STAFF REPORT ADDENDUM

APPLICATION RZ/FDP 2014-LE-008

LONG BRANCH PROPERTY

CONCEPTUAL DEVELOPMENT PLAN FINAL DEVELOPMENT PLAN (CDP/FDP)

Drawing Title
CDP/FDP LAYOUT

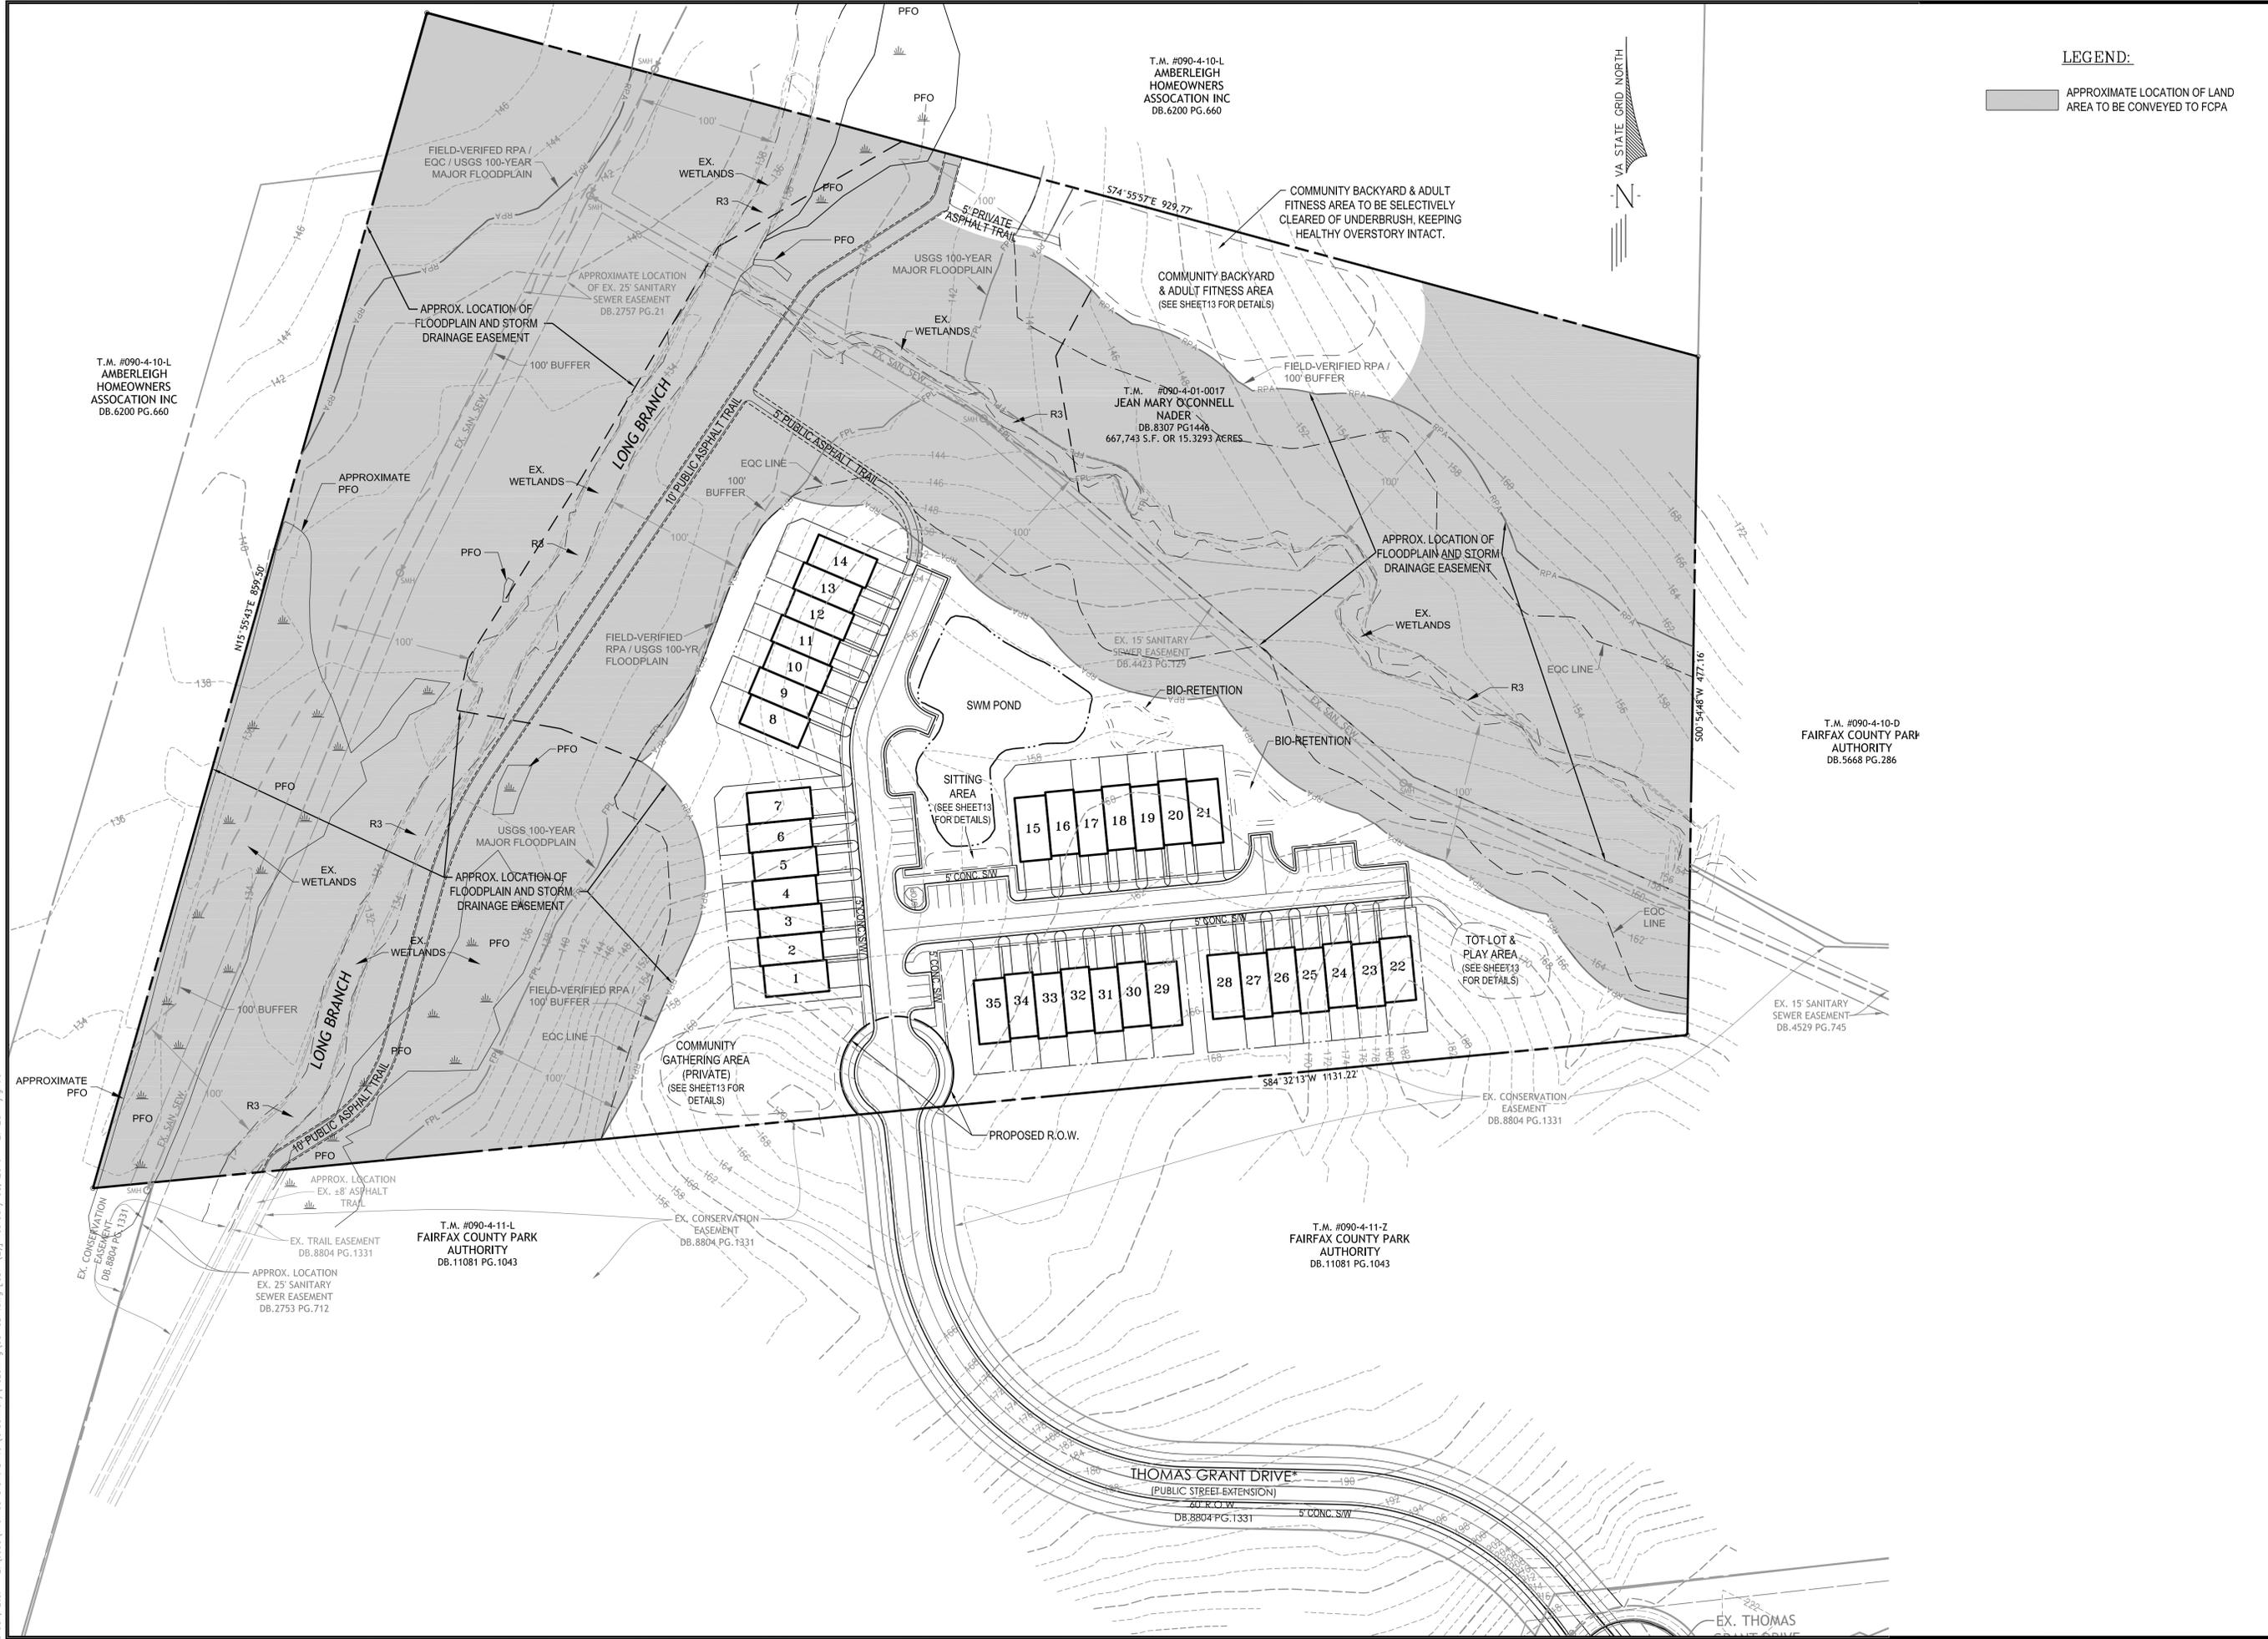
5. The retaining wall proposed along the southeast property line (approximately 12 feet away) has an anticipated height of up to 11 ft. and will mostly be created by excavation. Due to the additional temporary-excavation needed for wall construction and their impact on the survivability of existing vegetation on the adjoining FCPA property, it is recommended that a minimum horizontal separation distance be specified for the southeast wall, either in Proffer #1c and/or modifying note #1 on the CDP/FDP layout (sheet 5 of 13).

Drawing Title
PRELIMINARY BMP ANALYSIS

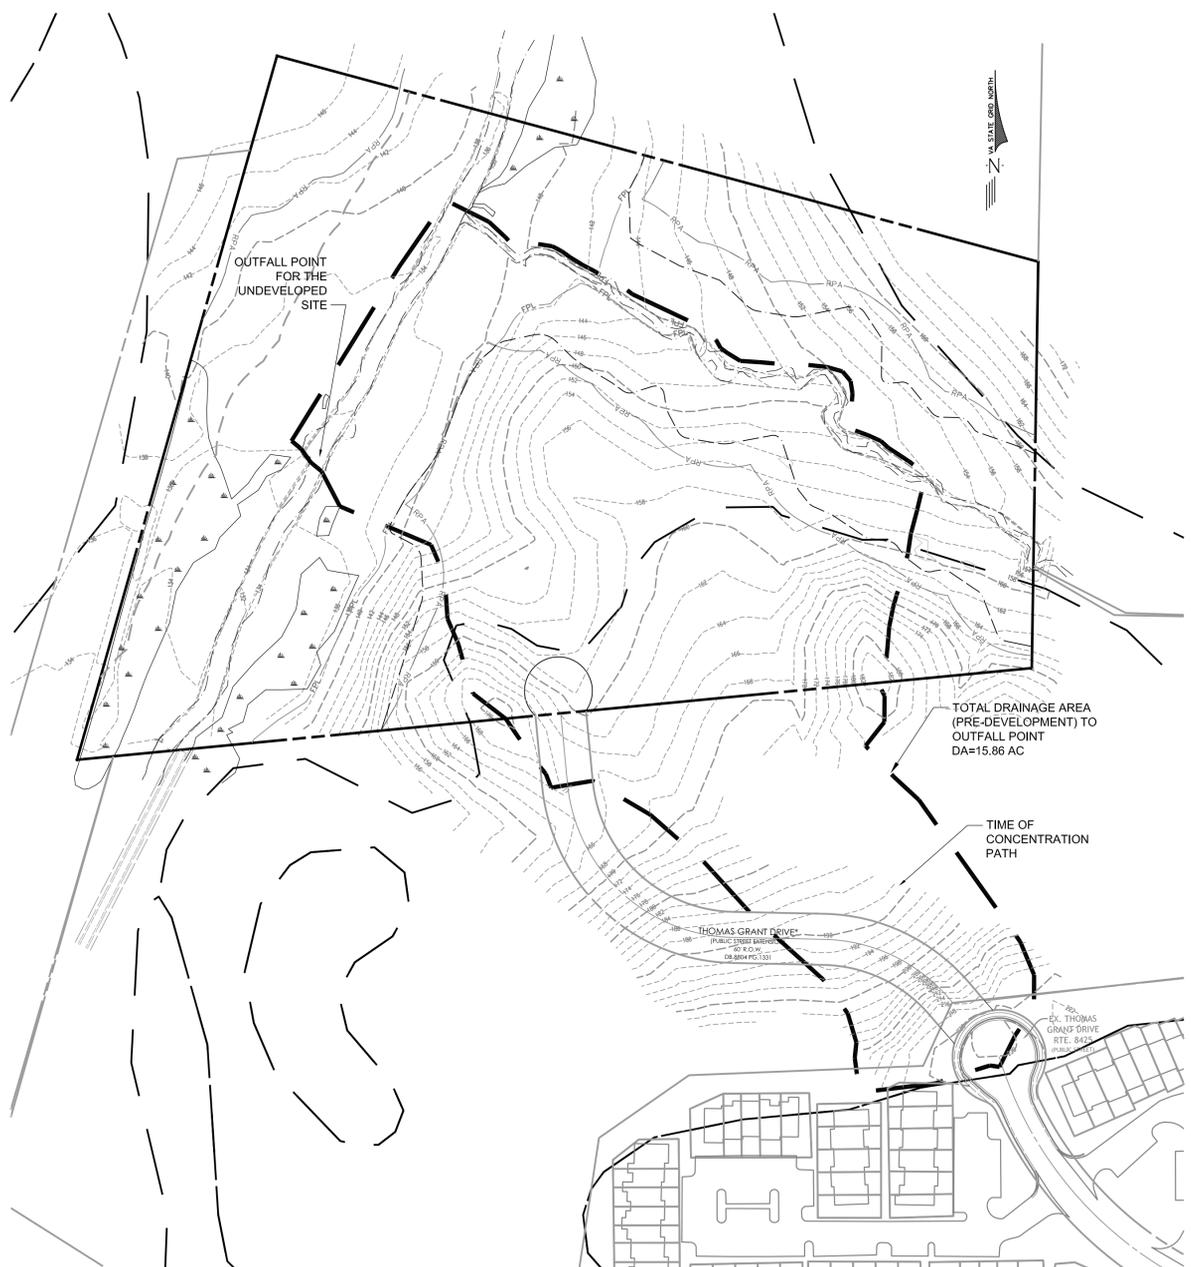
Applicant stated on sheet #8 that the stormwater quality control requirements will be met for this development by providing permeable pavement (Level 1) and Bioretention Basin (Level 2) Field run soil boring result to is required to ensure water table sufficiently below the ground for

CONCEPTUAL LOT DETAIL

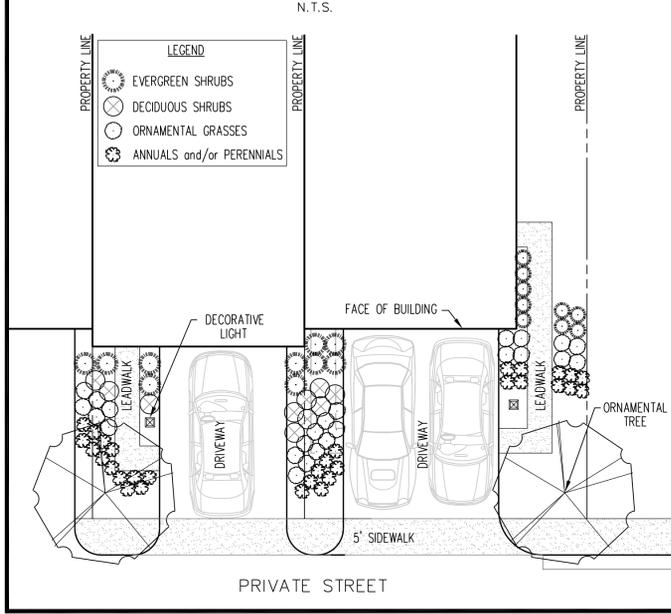
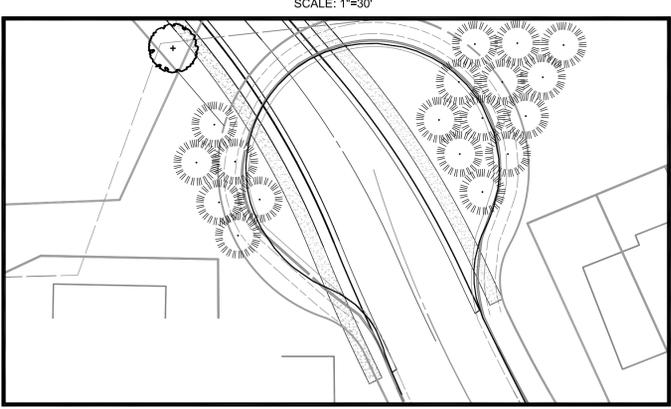
- B. A Conceptual Court Replanting landscape graphic is provided on Sheet 12 of the CDP/FDP that depicts evergreen trees both inside and outside of the existing cul-de-sac of Thomas Grant Drive. This landscaping is depicted, and shall be installed, to mitigate the potential impact of vehicle headlights on the Island Creek residents in the vicinity of the existing cul-de-sac; however, this landscaping may only be installed with the consent of the Island Creek Board of Directors. If the Island Creek Board of Directors does not consent to the installation of this landscaping, then this proffer shall be satisfied with the provision of a certified check in the amount of \$2,000.00 to the Island Creek Board of Directors, which funds may, but are not obligated to, be used to provide alternative measures to mitigate the potential impact of vehicle headlights.

Figure 2: Revised layout

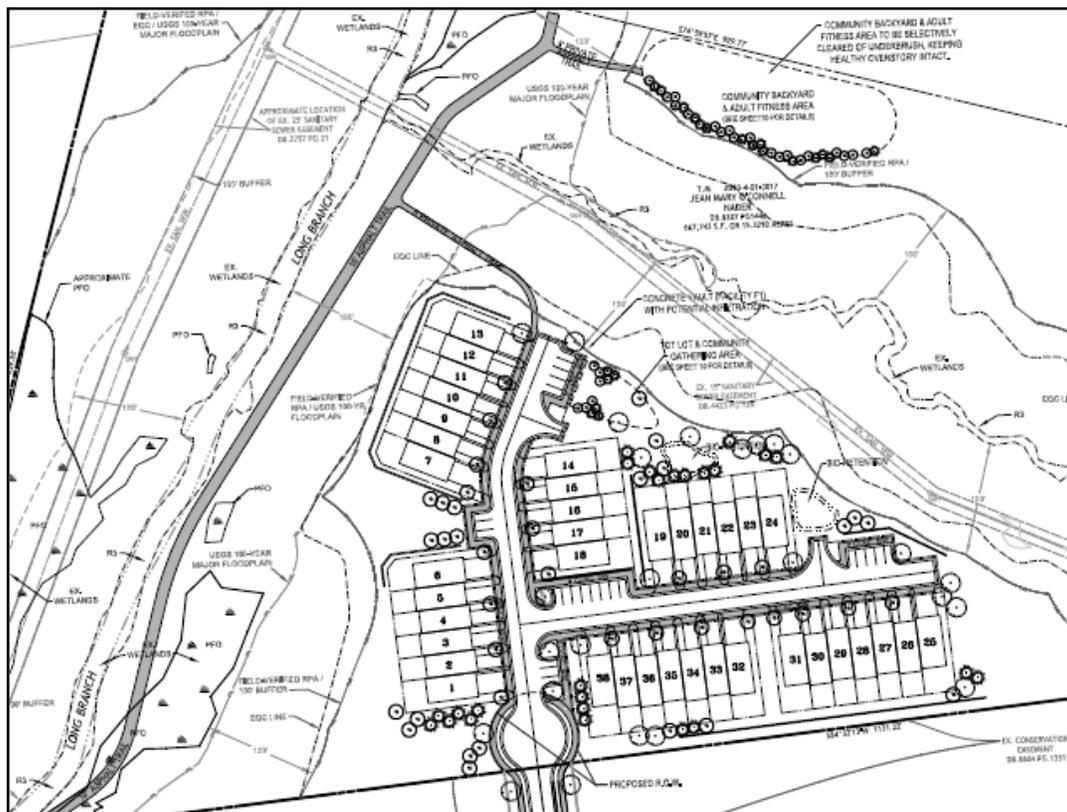
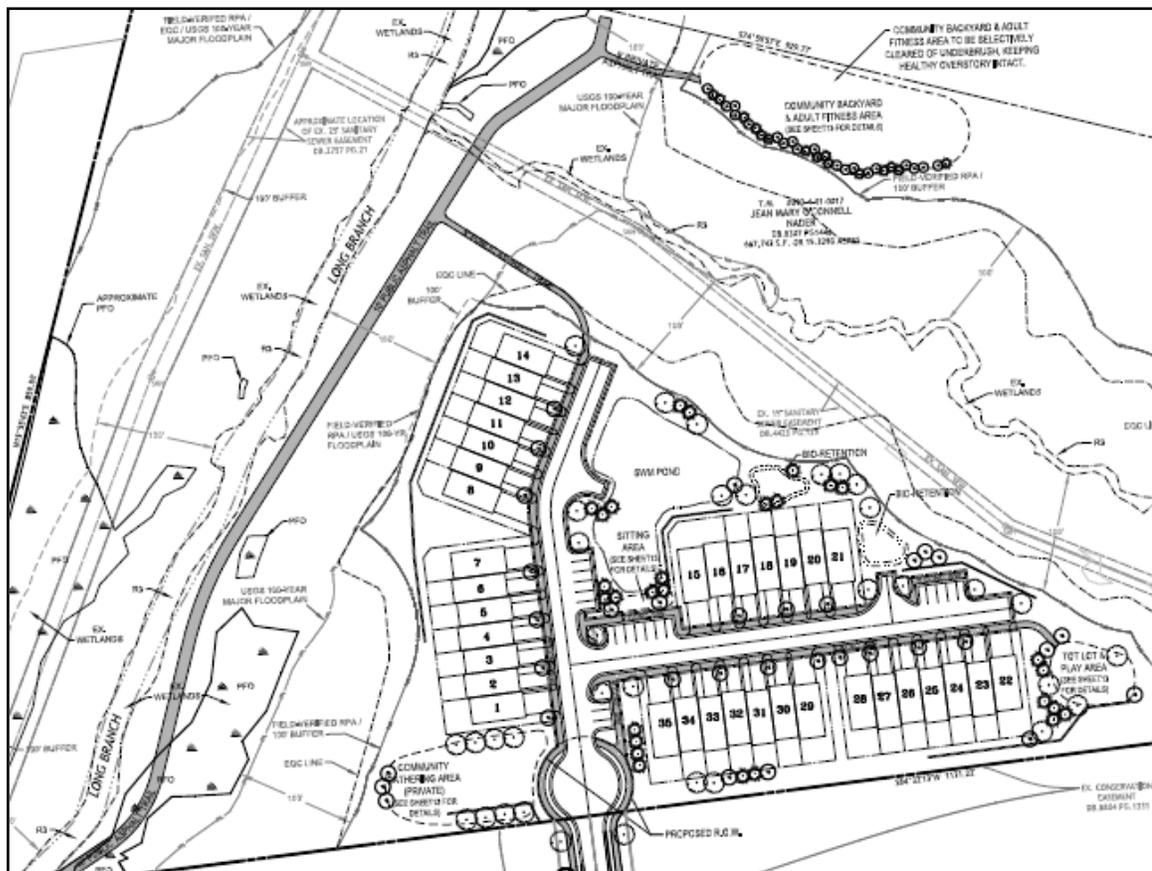
- Layout** (Sheet 5 of the CDP/FDP): The layout of the site has been revised in order to accommodate a proposed stormwater management pond (rather than the previously proposed underground stormwater management facility) and the reduction of units. The stick of five townhomes previously proposed to the east of the north-south private street has been removed (Units 14-18 on the previous CDP/FDP), with one unit being relocated to the stick of townhomes to the northwest of the onsite cul-de-sac (Units 1-6 on the previous CDP/FDP), and one unit being relocated to the stick of townhomes north of the east-west private street (Units 19-25 on the previous CDP/FDP). The CDP/FDP also shows minor revisions to the layout of the guest parking and community open space (which are discussed in further detail later in this report). In addition, the limits of clearing and grading no longer encroach into the RPA.
